Report to the Future Melbourne Committee

**Ministerial Planning Referral: TPM-2020-22
Lot S9, 208 - 226 Harbour Esplanade, Docklands**

2 February 2021

Figure 6: Diagram showing preferred building heights. Subject site marked by yellow arrow (source: Digital Harbour Development Plan (2011), Pg. 41).

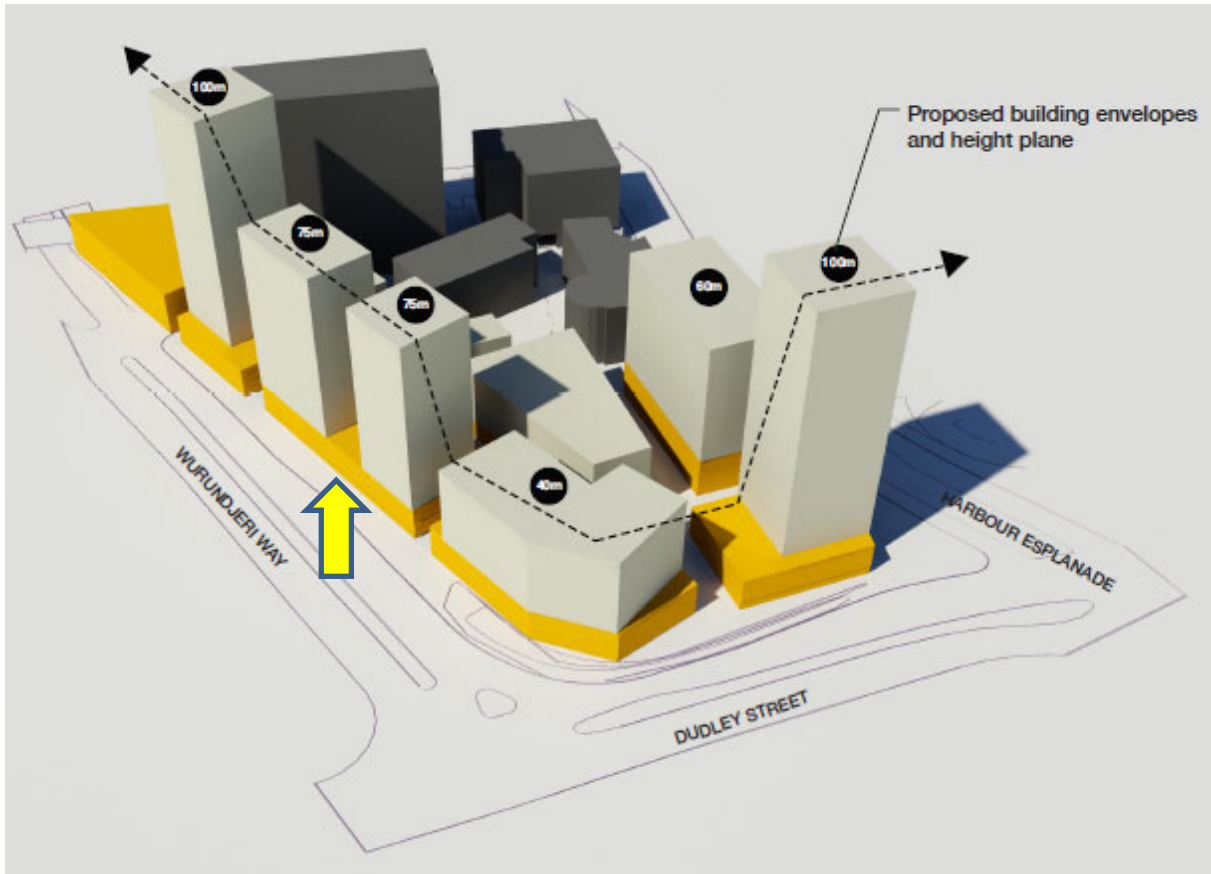
As such, the proposed building would step down towards the approved adjacent development and, in turn, continue the transition in heights downward from south to north as envisaged by the Digital Harbour Development Plan (refer Figure 6 above).

Though the reduced height of the northern-most tower would interrupt the aforementioned downward transition in building heights envisaged by the Plan (refer Figure 6), this height would not be so dissimilar to that of the approved adjacent building to the north (81.9 metres) that it would appear incongruous. Importantly, it is considered that this relatively minor difference in height would not generally be observed from the public realm, including Central Green.

Figure 10: The extent of shadows cast by the proposed building at 11.00am on the equinox. The site is marked by the yellow arrow and Central Green is marked by the green arrow

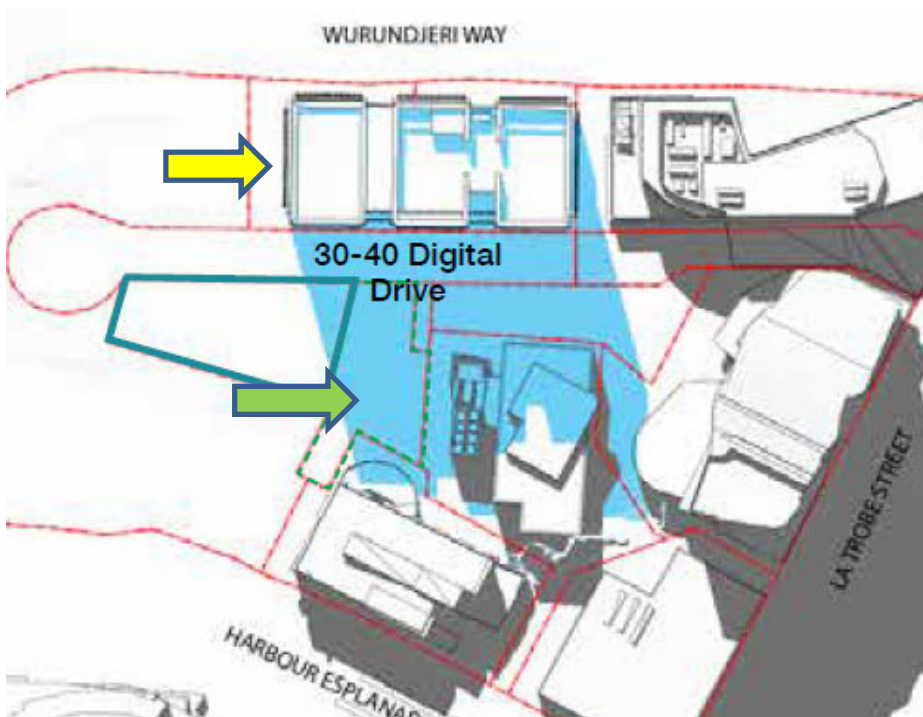
As Figure 10 shows, lengthy shadows would be cast over Central Green at 11.00am. At 12 noon these shadows would reduce and at 1.00pm the development would not overshadow this public open space, on 22 September.

Figure 15: Approved layout of Digital Drive
(source: Digital Harbour Development Plan (2011), Pg. 72)

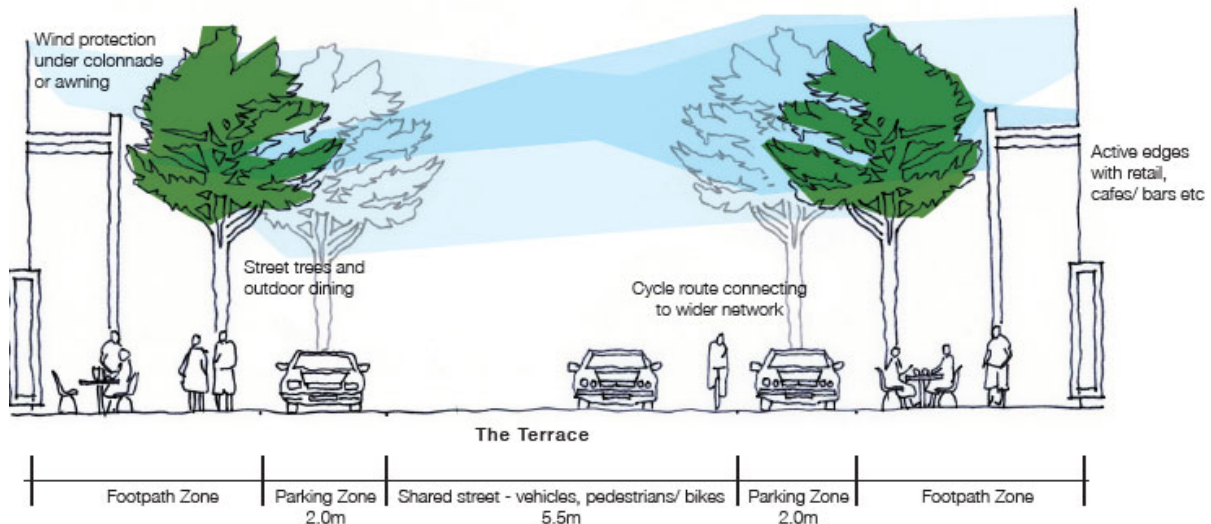
This configuration and presentation does not appear to accord with the preferred road layout shown in the 2011 Development Plan (as set out in Figure 15 below). As such, Council's Civil Engineers have requested that this roadway be amended to reflect the configuration of the remainder of Digital Drive (as approved in association with adjacent developments). This effectively requires the provision of a 20-metre wide connector road reserve.

- Digital Drive must be constructed in accordance with Council's standards. To this end, this roadway should be a 20-metre wide connector road and not a 15-metre wide shared street as shown on the application plans;
- The roadway should comprise two lanes, indented parallel parking on both sides of the street and five metre wide footpaths;
- These measures will ensure that that part of Digital Drive forward of the site matches the remainder of the roadway, as approved in association with neighbouring developments; and
- The written consent of VicRoads is required for any works within the Wurundjeri Way road reserve.
